UNITED STATES
NUCLEAR REGULATORY COMMISSION
WASHINGTON, D. C. 20555

Docket No. 50-271

RE: ACCEPTANCE CRITERIA FOR THE MARK I CONTAINMENT LONG TERM PROGRAM

NRC ACCEPTANCE CRITERIA
FOR THE
MARK I CONTAINMENT
LONG TERM PROGRAM

Figure 2.6-1 Schematic Diagram Illustrating the Methodology for Main Vent Impact and Drag

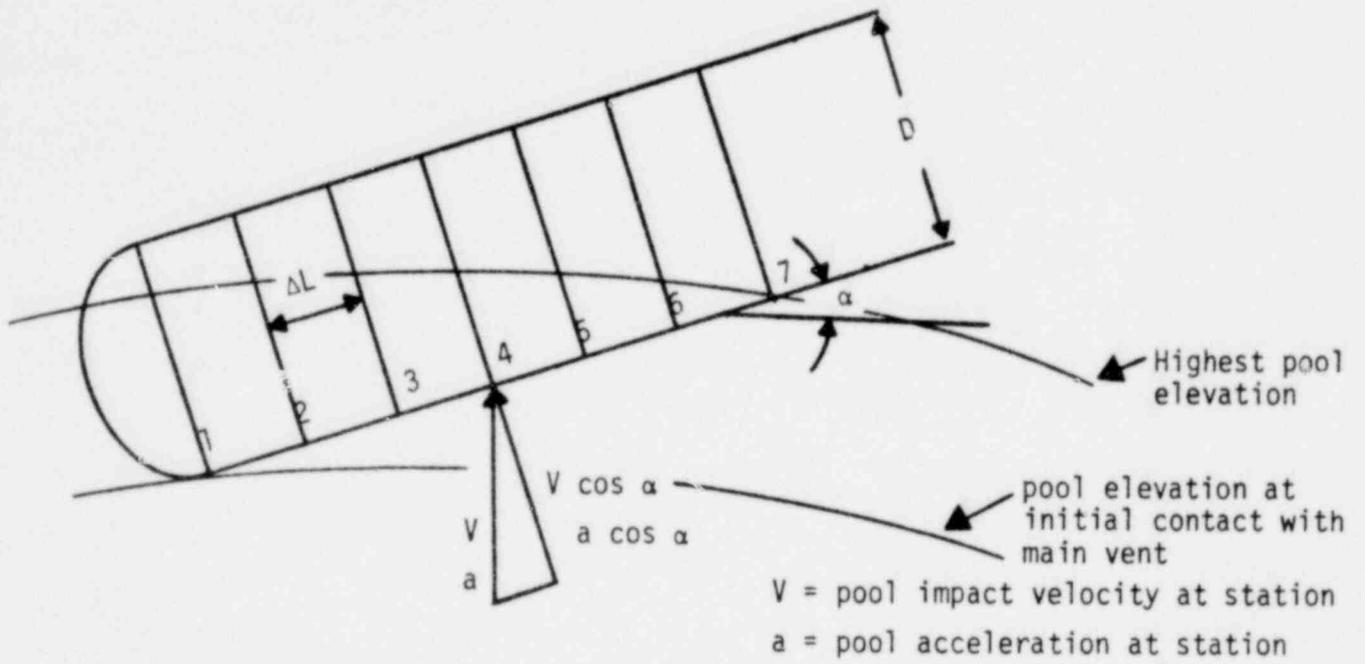
1. Subdivide the submerged portion of the main vent pipe into six equally wide segments (see Figure 2.6-1). If this subdivision results in $\Delta L < 0.3D$ fewer segments may be used such that $\Delta L \sim 0.3D$.
2. Determine the velocity and acceleration histories at Points 1 through 7 in Figure 2.6-1 from the QSTF data and appropriate corrections for longitudinal variations along the torus (at Point 7, only the initial impact velocity is required).
3. Using the velocity components normal to the vent pipe, calculate the impact and "steady" drag pressure using the method in Section 2.7.1 (Cylindrical Structures). At Point 7, only impact force is to be considered.

Using the acceleration components normal to the vent pipe, calculate the acceleration drag pressure using the equation

$$P_a = \frac{\rho}{2g_c} \left(\frac{\pi D}{144} \right) \dot{V} + \frac{F_{\text{static buoyancy}}}{DL}$$

4. Sum the pressures due to impact, viscous drag and acceleration drag and multiply by D to obtain force per unit length at Stations 1 through 7.
5. To obtain a smooth loading history for the main vent as a whole, the linear interpolation method suggested for the vent header deflector in Section 3.5 of NEDO-24612 may be used.

Figure 2.7-1 Pulse Shape for Water Impact on Cylindrical Targets

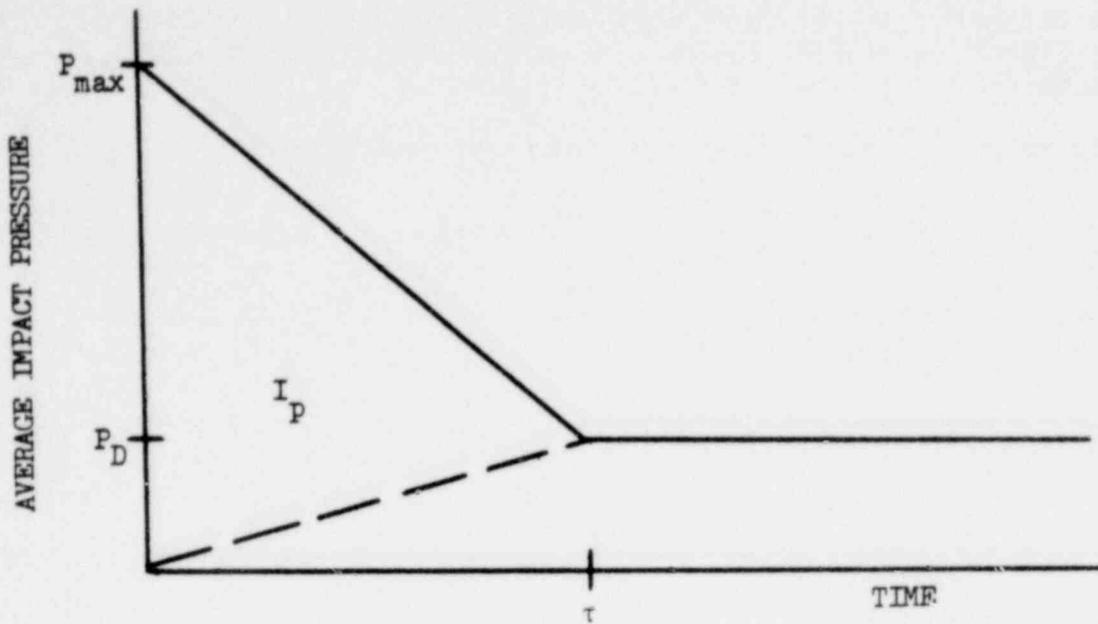
For cylindrical structures, the pressure transient which occurs upon water impact and subsequent drag is depicted in Figure 2.7-1. The parameters in Figure 2.7-1 shall be defined as follows:

1. The maximum pressure of impact P_{max} will be determined by

$$P_{\text{max}} = 7.0 \times \frac{1}{2} \left(\frac{\rho}{144} \frac{V^2}{g_c} \right)$$

Figure 2.7-2 Drag Coefficient for Cylinders Following Impact

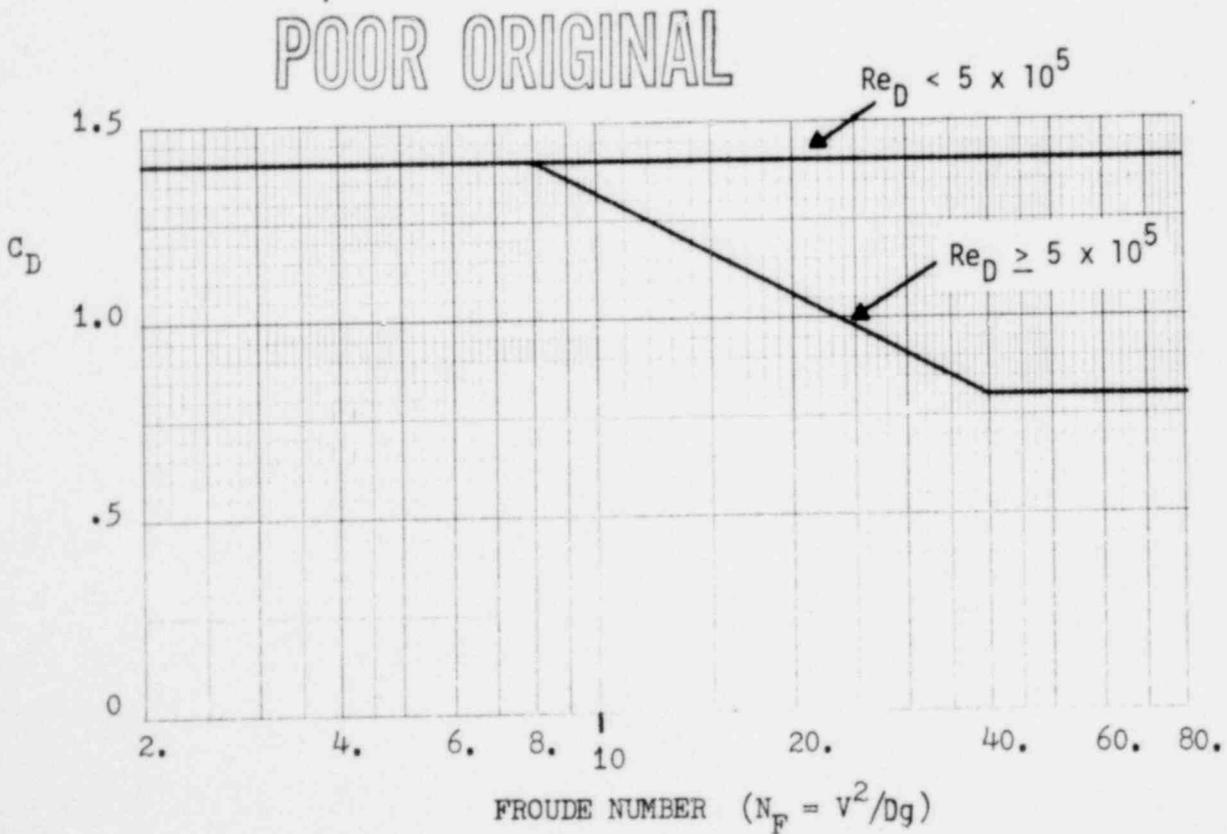
where P_D is the average drag pressure acting on the projected area of the target (psi), C_D is the drag coefficient as defined by Figure 2.7-2, and ρ is the density of water (lbm/ft³).

Figure 2.7-3 Pulse Shape for Water Impact on Flat Targets

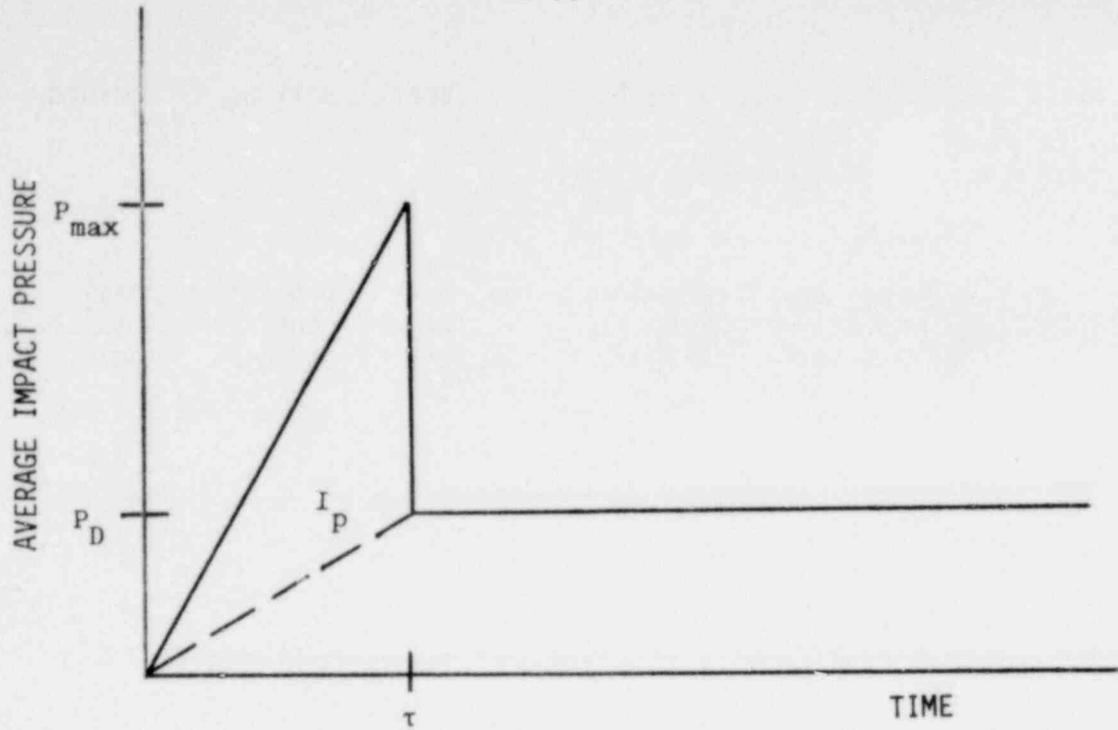
For flat-surface structures, the pressure transient which occurs upon water impact and subsequent drag is depicted in Figure 2.7-3. The parameters in Figure 2.7-3 shall be defined as follows:

1. The pulse duration (τ) is specified as a function of the impact velocity:

$$\tau = 0.0016W \quad \text{for } V \leq 7 \text{ ft/sec}$$

$$\tau = \frac{0.011 W}{V} \quad \text{for } V > 7 \text{ ft/sec}$$

Figure 2.7-4 Pressure Drop Due to Flow Across Gratings

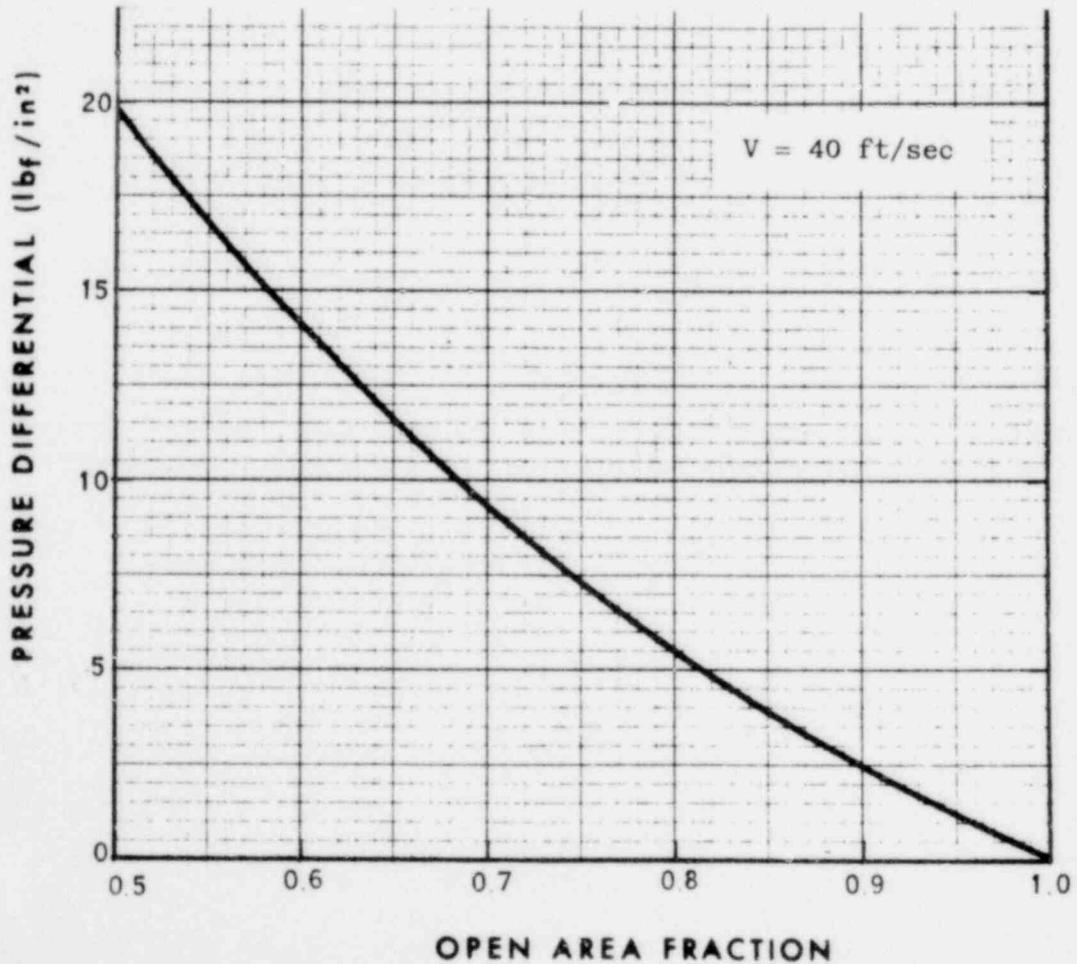
The static drag load on gratings in the pool swell zone of the wetwell shall be calculated for gratings with open areas greater than or equal to 60% by forming the product of the pressure differential (figure 2.7-4) and the total grating area (not only the area of the metal bars). The pressure differential curve in Figure 2.7-4 is based on a velocity of 40 ft/sec. If the maximum pool velocity in the area where gratings are located differs from 40 ft/sec, the force on the grating will be calculated as follows:

$$F = \Delta P \times A_{grating} \left(\frac{v_{max}}{40} \right)^2$$

Figure 2.7-5 Impulsive Impact Loading Region for Structures with a Natural Frequency Less Than 30 Hz

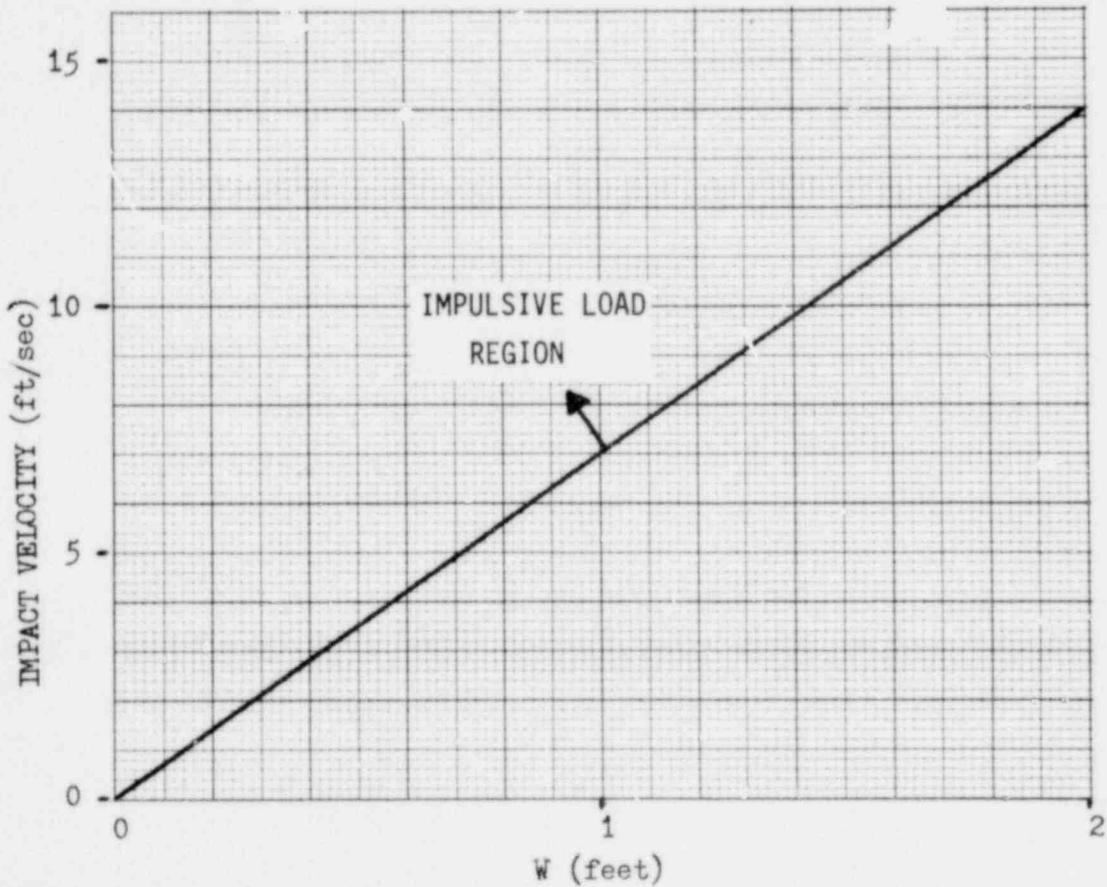
For structures with a natural frequency less than 30 Hz, loading can be treated impulsively (i.e., independent of pulse shape) when the conditions fall into the region above the straight line shown in Figure 2.7-5.

Figure 2.7-6 Effect of Drag Following a Parabolic Impact Pulse

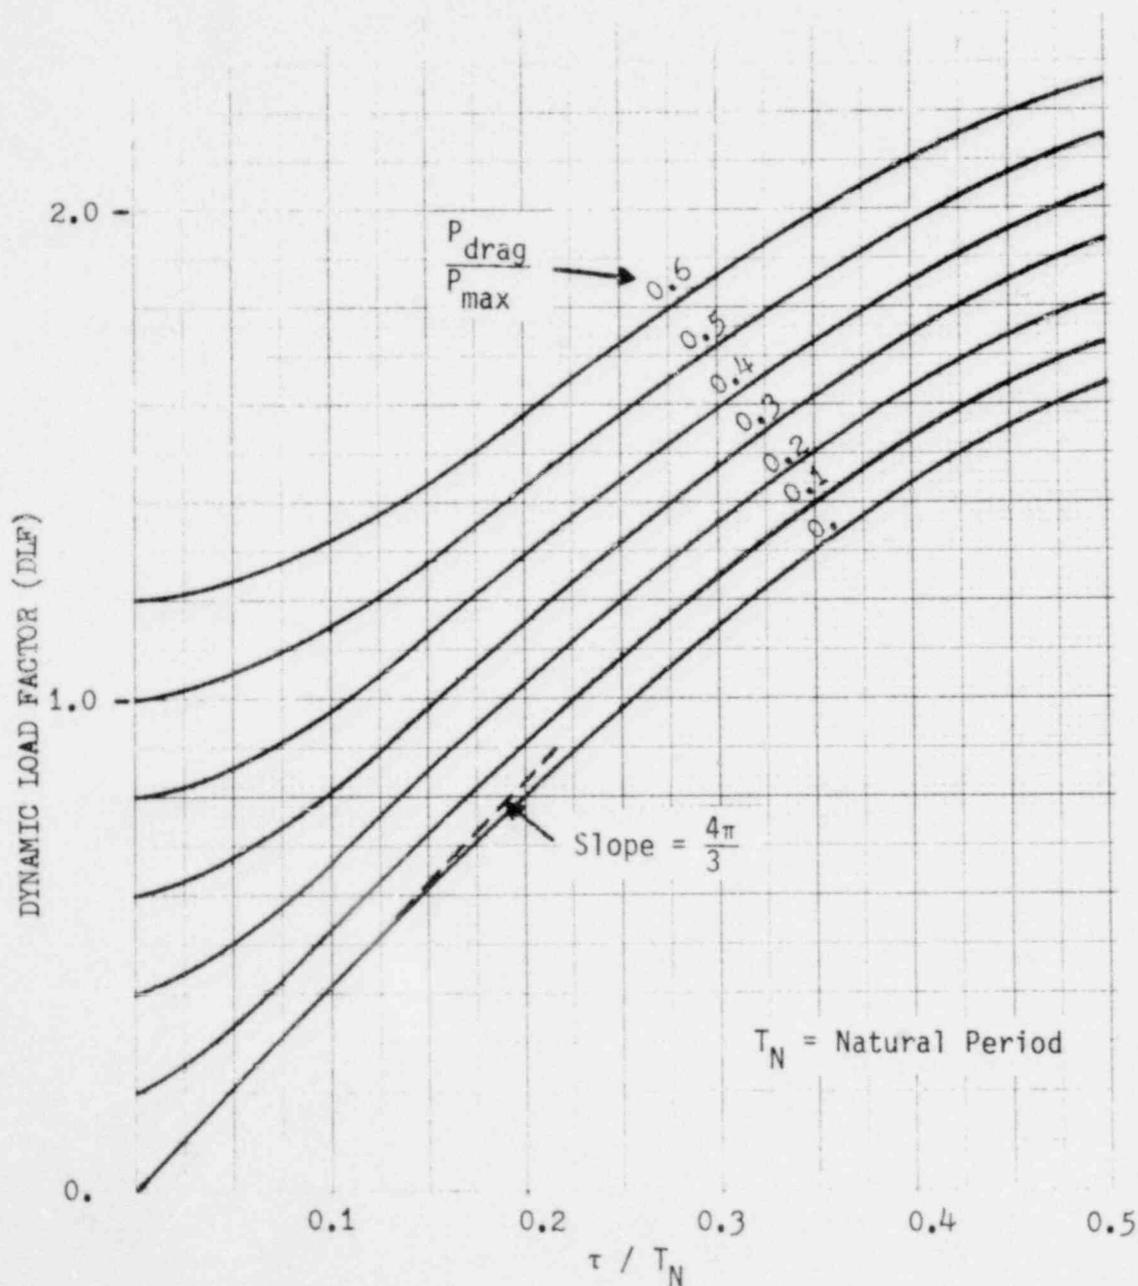
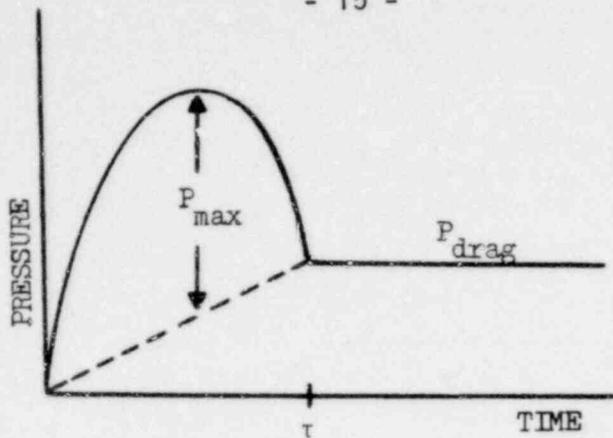
- c. Determine the dynamic load factor (DLF) from Figure 2.7-6, corresponding to the two cases: (1) parabolic pulse without drag and (2) parabolic pulse followed by drag.
- d. Multiply the calculated stress by the factor

$$DLF_{with\ drag}/DLF_{w/o\ drag}$$

Figure 2.10-1 Impact Force Transient for Addition to the Empirical Data for Deflector Types 1 - 3.

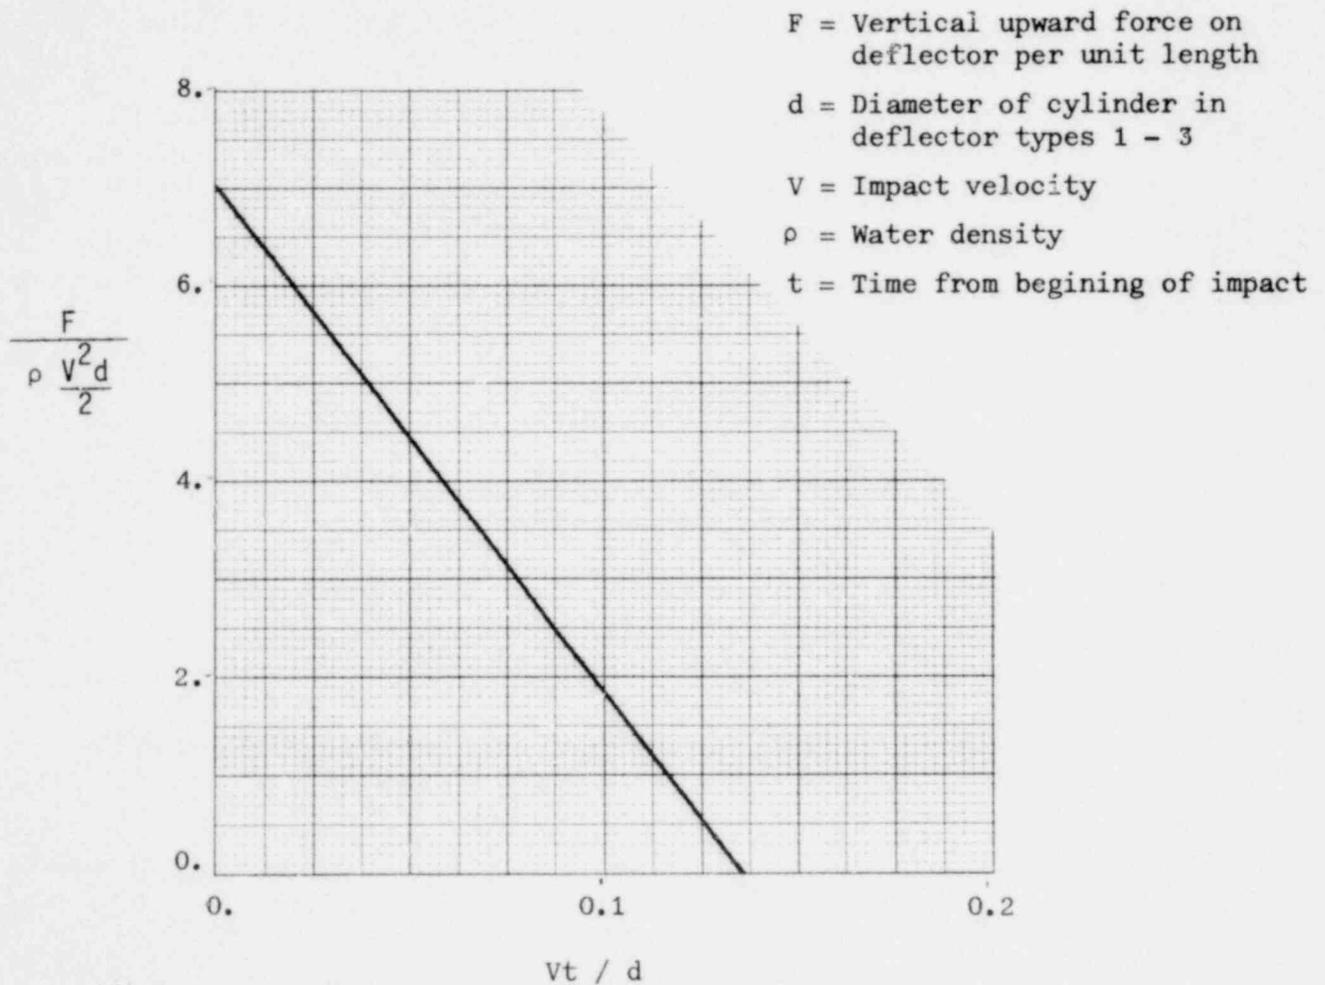
1. If the QSTF deflector load measurement does not have a sufficiently fast response time to resolve the initial impact pressure spike for the deflector types 1 - 3, inclusive, the loading transient shall be adjusted to include the empirical vertical force history of the spike shown in Figure 2.10-1. This impulse need not be applied for the type 4 deflector.
